River Medway (Flood Relief) Act 1976

The Environment Agency's Application to vary the Scheme for the operation of the Leigh Flood Storage Area

Objection to the application

FROM Jeremy & Katharina Thompson

**Flooding to the shed
& green shaded area
(see [REDACTED] map)
24/12/2013**

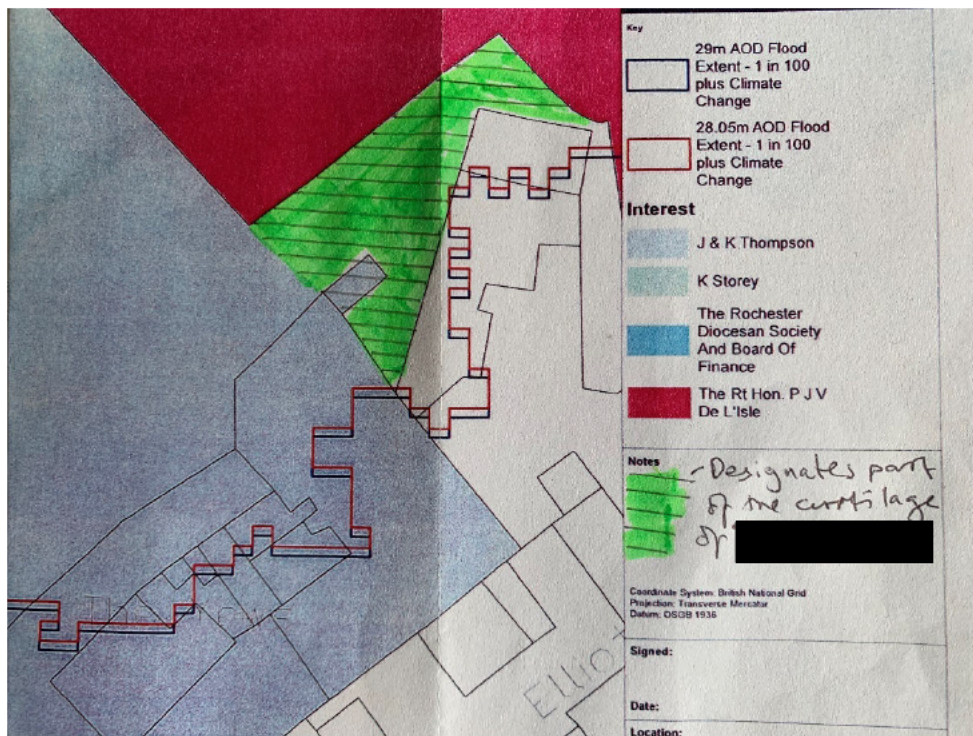
The detailed mapping and measuring of our property [REDACTED] shows a small area to the East of my land (the attached map shows this) that used to belong to the estate but for the last 40 years or more has been part of the curtilage of [REDACTED].

Land marked in green on the map indicates part of [redacted] curtilage at the Eastern end of the property

We have told the EA and their representatives about this on many occasions as it is the lowest lying area of our property and does flood by over 1 ft when the barrier is fully raised. The photo attached shows this area of the garden and the adjacent field, owned by the Estate, underwater in 2019. The same thing happened in 2013/2014, also flooding the old barn and a shed in the same piece of land. On both occasions I did not make a claim against the EA on either occasion as I did not want to trigger an insurance claim for flooding on this property. We have never made an insurance claim for flooding on this property, and neither did the previous residents.
